**Historic Architectural Review Commission  
Staff Report for Item 5**

**Application Number:** H2023-0023

**Address:** 1021 Grinnell Street

Demolition of non-historic additions and shed at rear.

Title:  
DEMOLITION FLOOR  
PLAN AND PROPOSED  
FLOOR PLAN

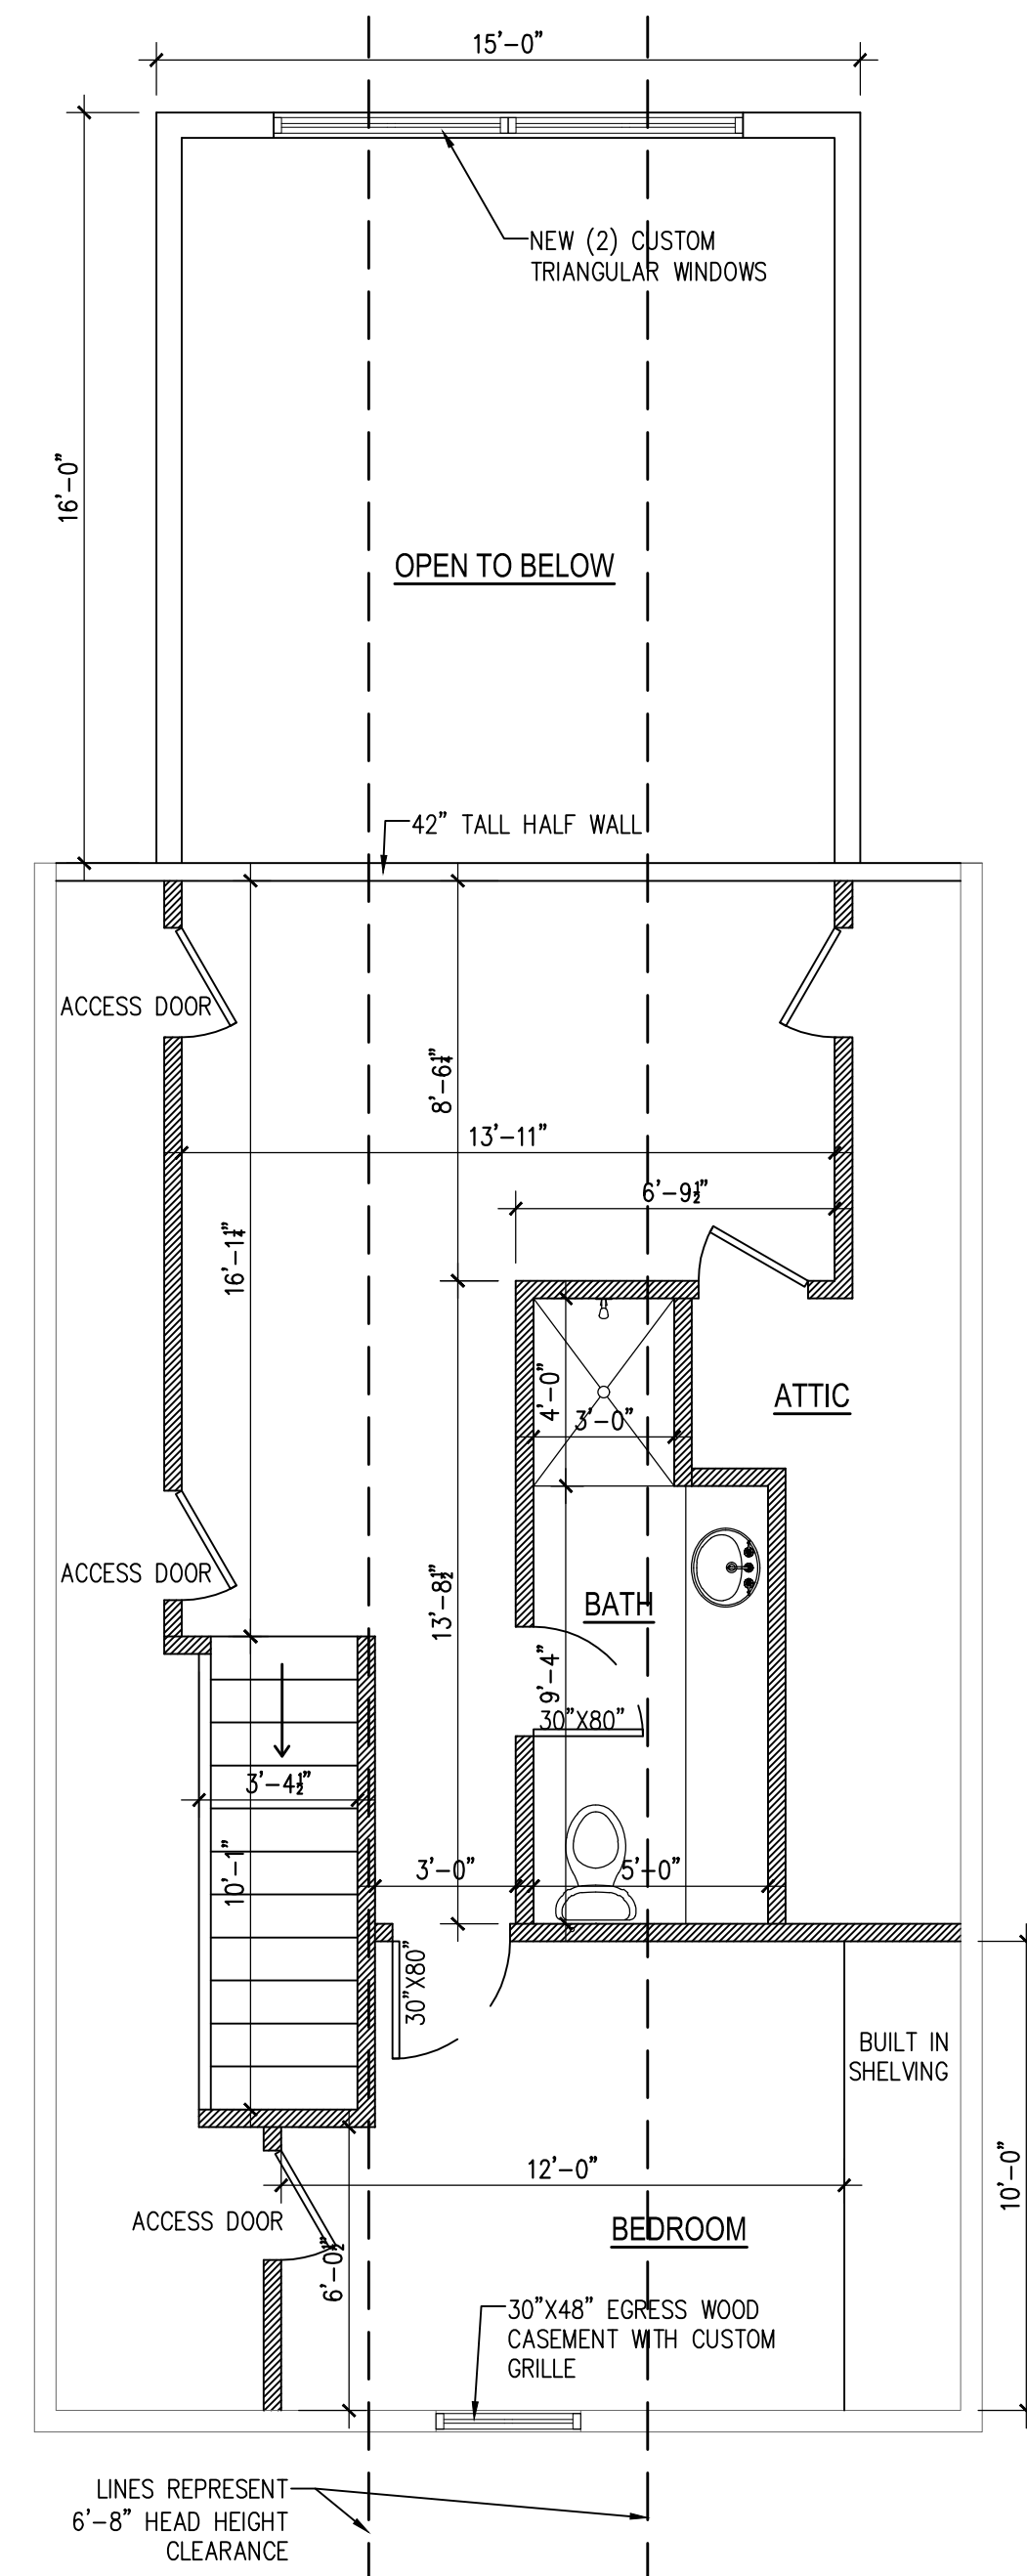
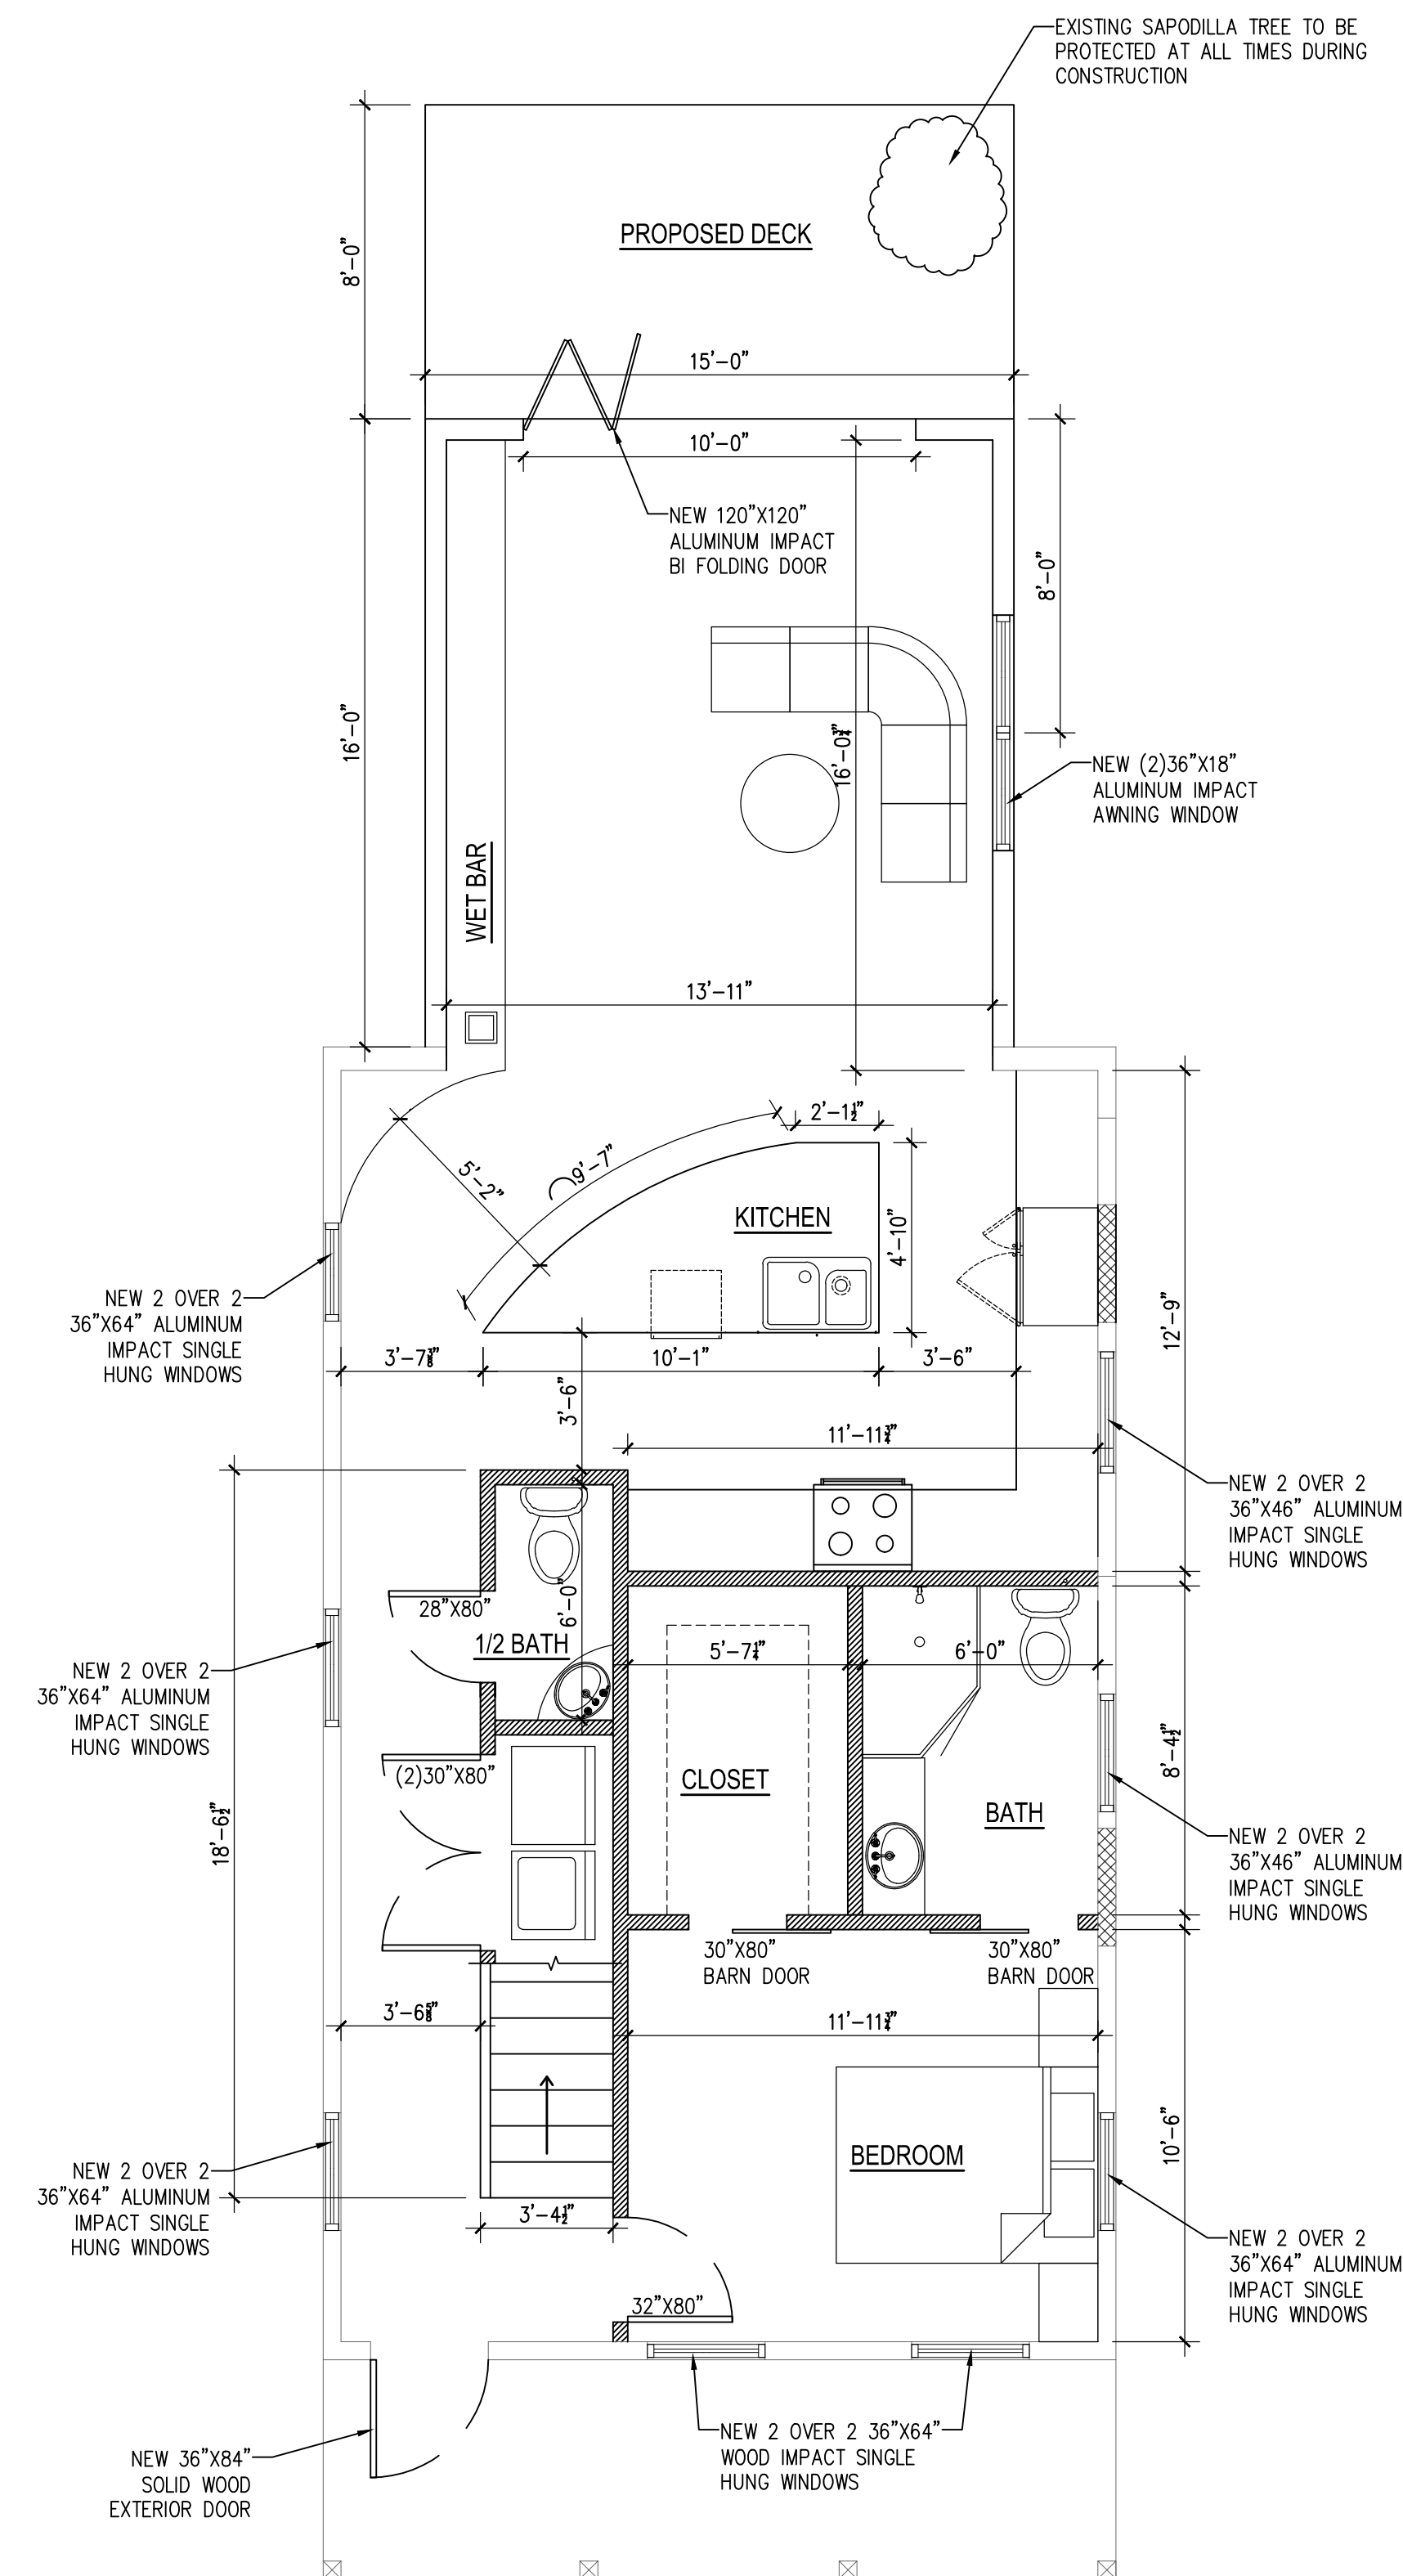
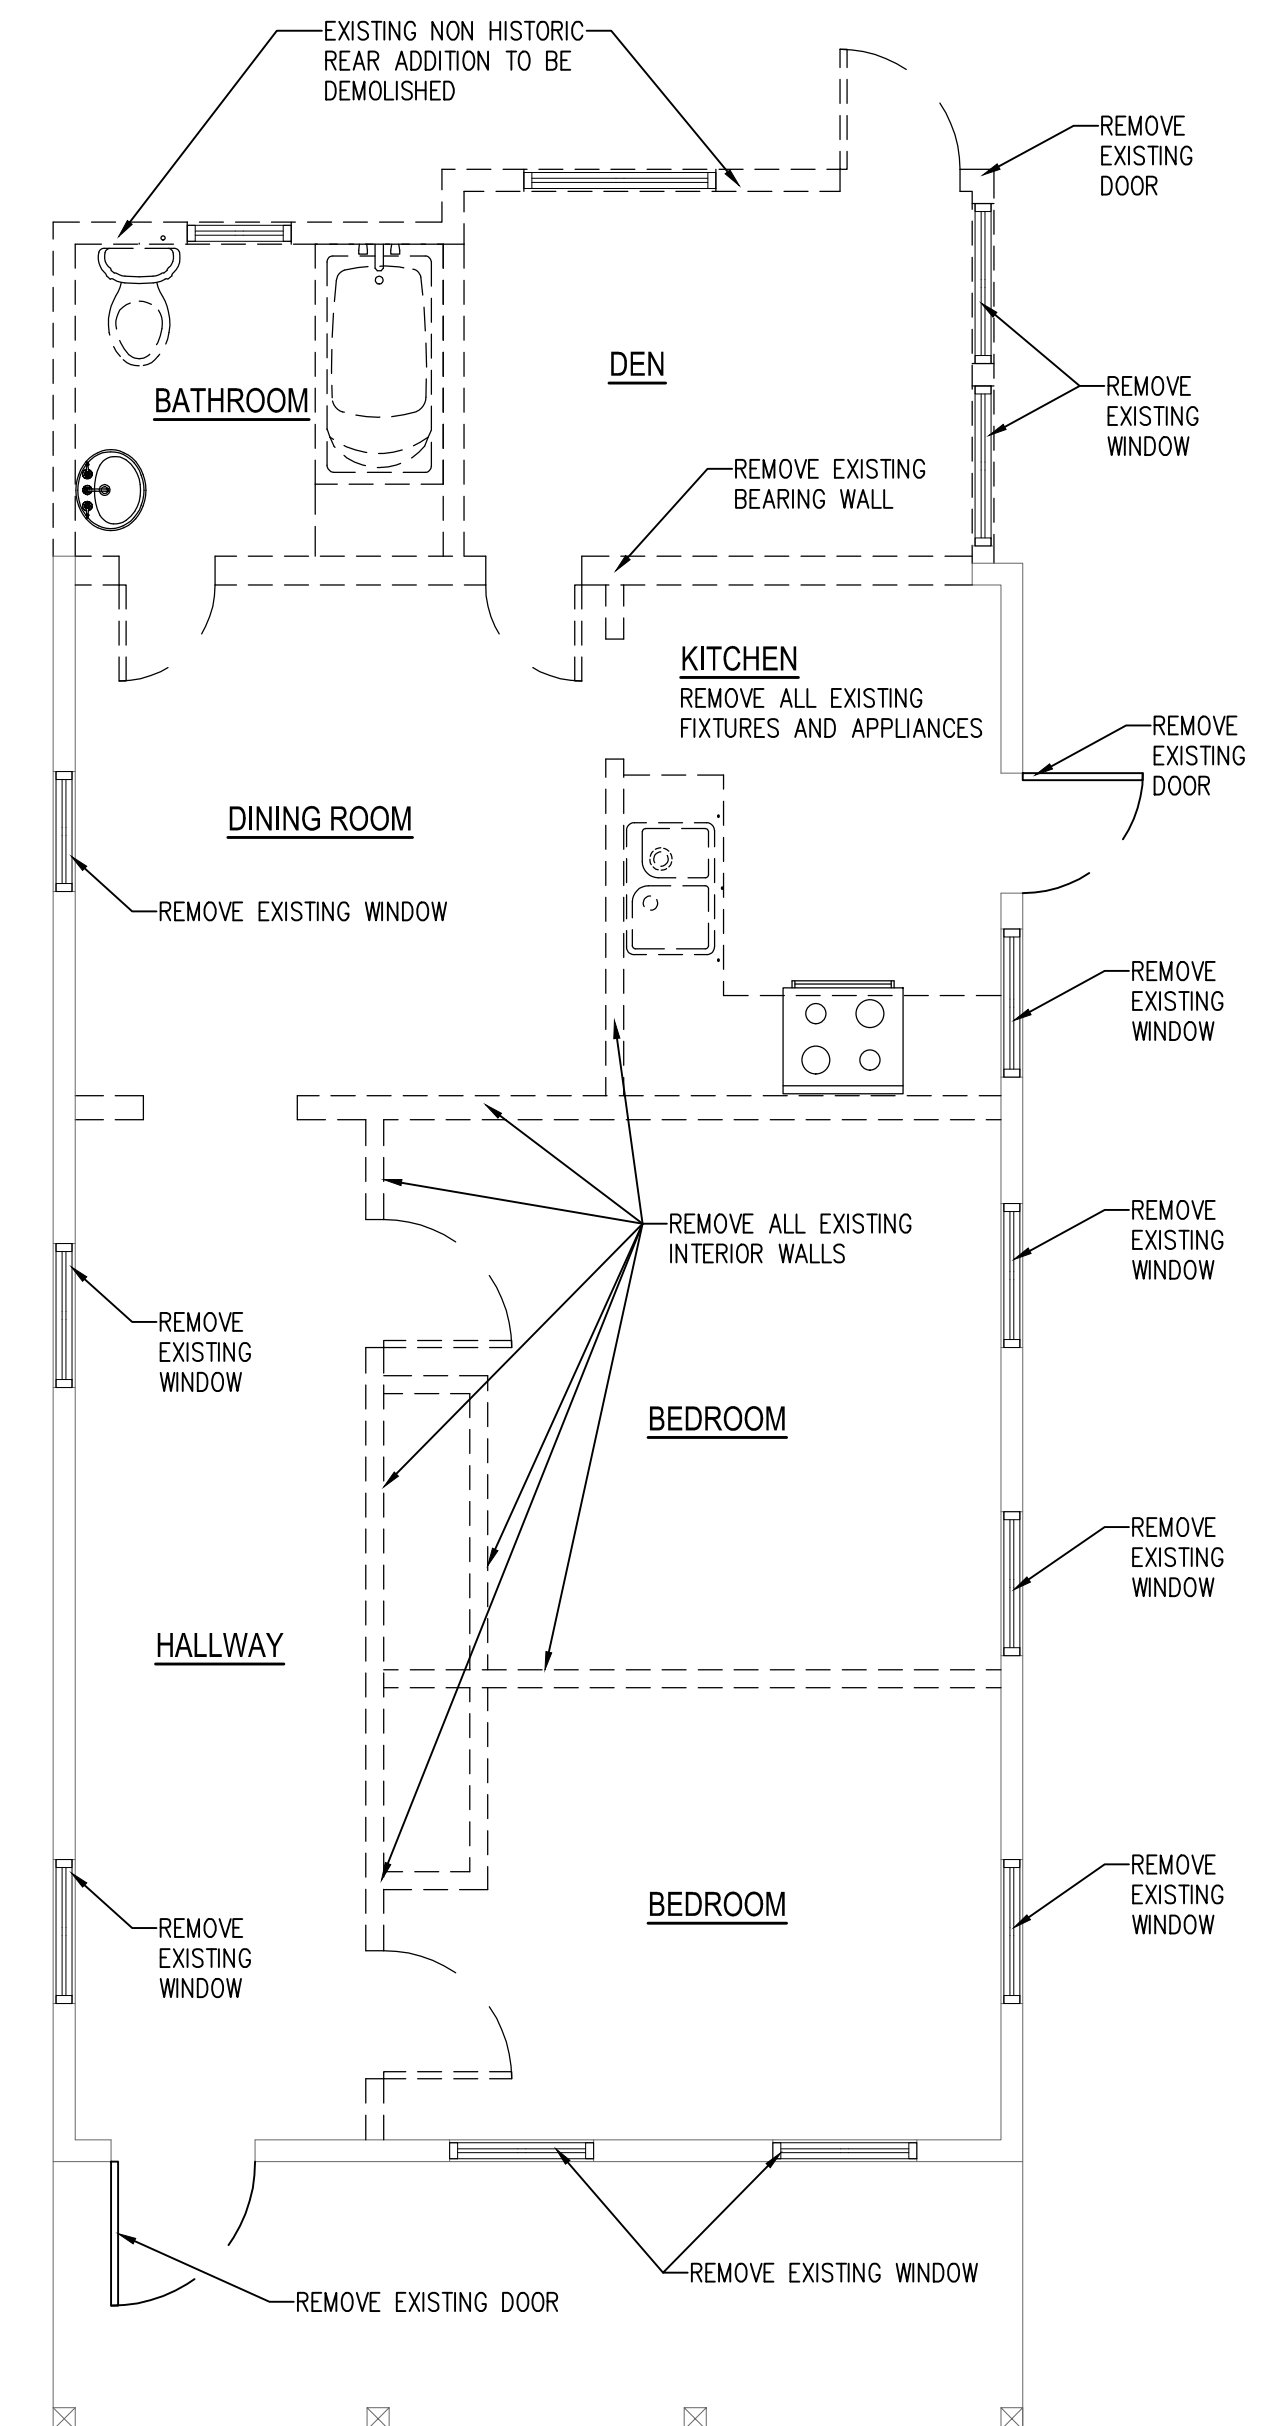
The Certificate of Appropriateness proposes the demolition of a non-historic rear additions and roof. The plans also include the demolition of a derelict metal shed and hencoop.

It is staff's opinion that the structures under review are not character defining features to the historic house or the site, therefore they are not significant elements of the historic district.

The proposed structures to be demolish are not historic.

The non-historic structures under review cannot be consider significant later additions that contributes to the historic character of the property or neighborhood.

It is staff's opinion that the structures under review will not qualify to be contributing to the district in a near future.

In conclusion, it is staff's opinion that the request for demolition of non-historic structures can be considered by the Commission as it meets the criteria for demolition stated under the Land Development Regulations. If approved, this will be the only required reading for demolition.
